**TENNESSEE VALLEY AUTHORITY
WATTS BAR NUCLEAR PLANT UNIT 1
CONTAINMENT INTEGRITY ANALYSES
FOR ICE WEIGHT OPTIMIZATION
ENGINEERING REPORT**

WCAP-15699

REVISION 1

APPENDIX A - FSAR MARKUPS

FIGURE 6.2.1-1. PRESSURE VS. TIME

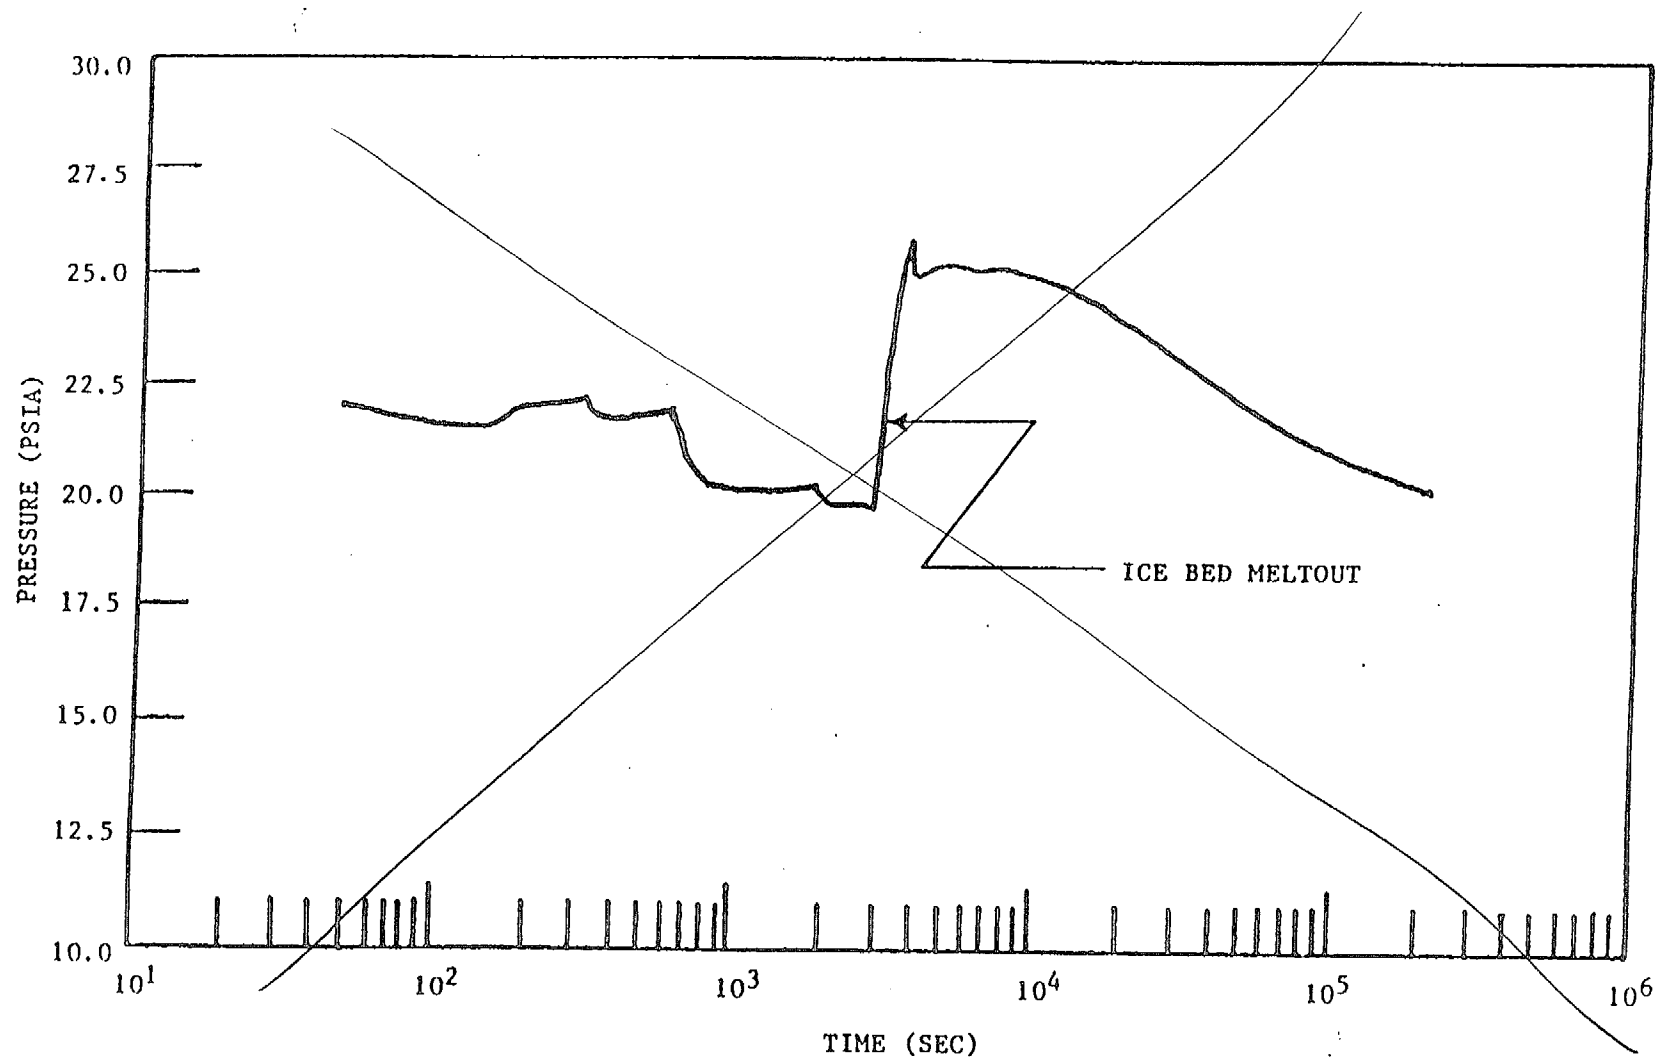
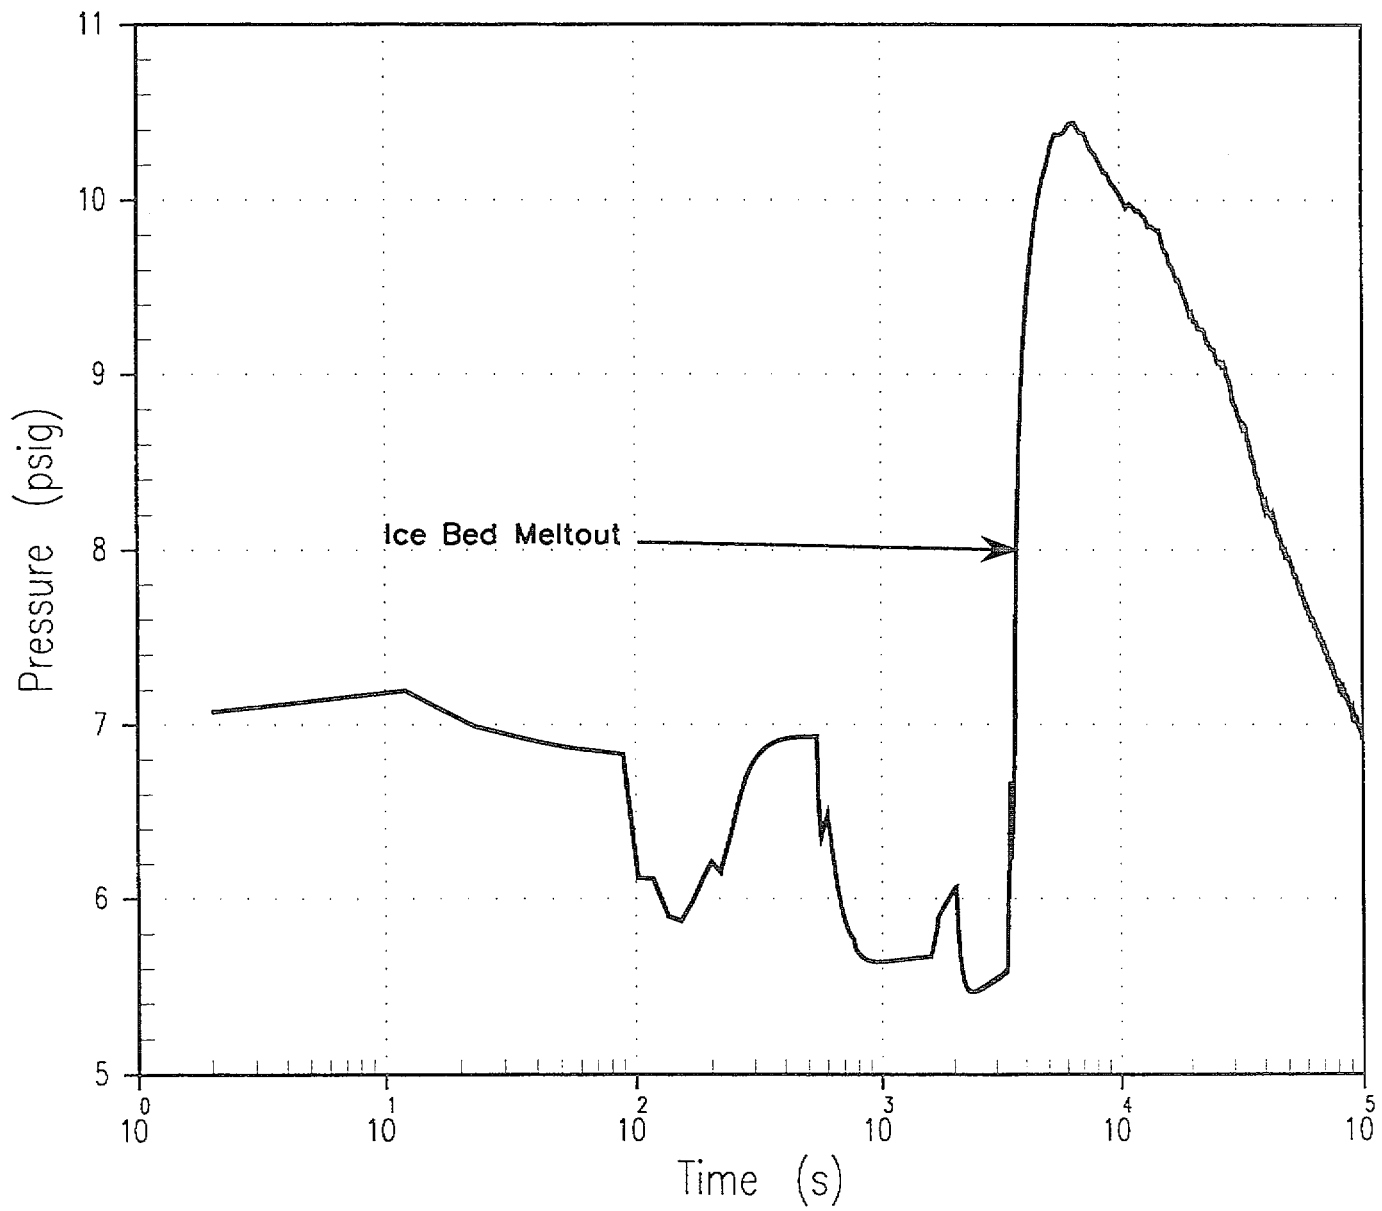
As can be seen from Figure 6.2.1-1 the maximum calculated Containment pressure is ^{6373.5} ~~41.21~~ psig, occurring at approximately ^{10.438} ~~2600.9~~ seconds. The transient shown does ~~not~~ account for hydrogen partial pressure as a result of the post DBA LOCA hydrogen production discussed in Sections 6.2.5 and 15.4.1.2. Accumulation of hydrogen prior to recombiner operation can account for approximately 0.25 psig at the time of containment peak pressure, ~~for a total of 41.46 psig.~~

FIGURE 6.2.1-4A. ICE MASS VS. PRESSURE

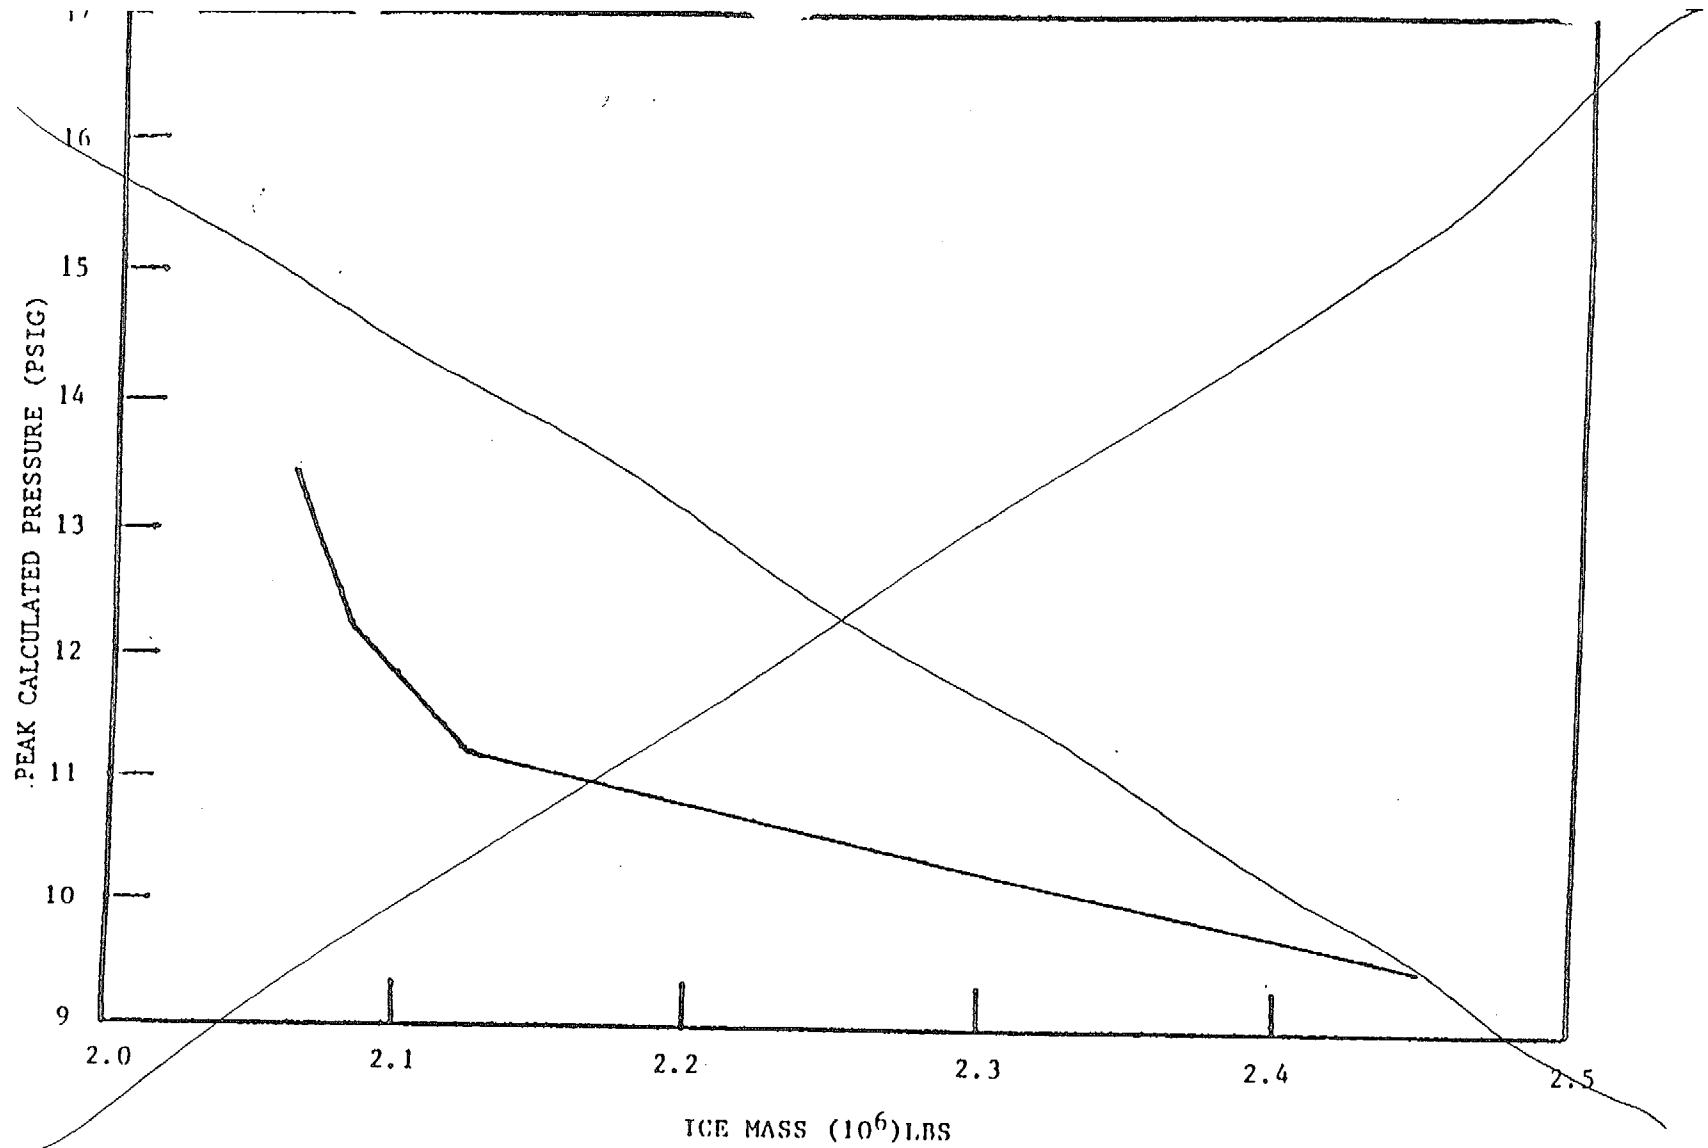
delete
